Work Order ID 92810

Item Name: Replacement Window Assembly

DRAWING NO. D3290	TITLE REPLACEMENT WINDOW ASSEMBLY	REV. C	DART AEROSPACE LTD ENGINEERING ORDER		D.E.O. NO. D3290-C-1	SHEET NO. SHEET 1 OF 1	SCALE NTS
DRAWN 90	CHECKED 15	MFG. APPR. E	APPROVED MD		DE APPR. #		
DATE 09.09.18	DATE 09.09.18	DATE 09.09.18	DATE 09/09/21		DATE 09/09/21

**D3290-3 WINDOW****D3290-3 NOTES:**

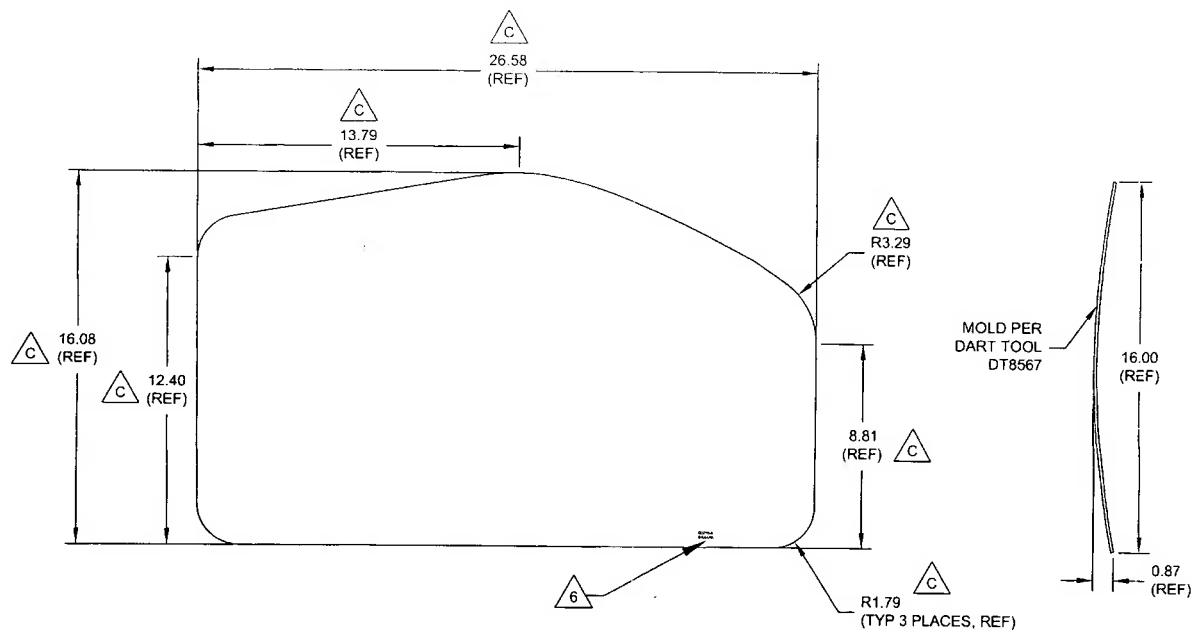
CHANGE MATERIAL THICKNESS OF D3290-1 FRAME TO 0.063 FROM 0.040. REF PAR 09-033.

MATERIAL CALL-OUT OF D3290-1 FRAME ON SHEET 1 IS AMENDED AS FOLLOWS:

- 1) MATERIAL: 6061-T6 (OR 6061-T62) ALUMINUM SHEET ~~0.040 THICK~~ 0.063 THICK (REPLACE)  
 PER AMS-QQ-A-250/11 OR AMS 4025 OR AMS 4027  
~~(REF. DART SPEC. M6061T6S.040)~~ REF. DART SPEC. M6061T6S.063 (REPLACE)  
 OR  
 5052-H32 ALUMINUM SHEET ~~0.040 THICK~~ 0.063 THICK (REPLACE)  
 PER AMS-QQ-A-250/8 OR AMS 4016  
~~(REF. DART SPEC. M5052H32S.040)~~ REF. DART SPEC. M5052H32S.063 (REPLACE)
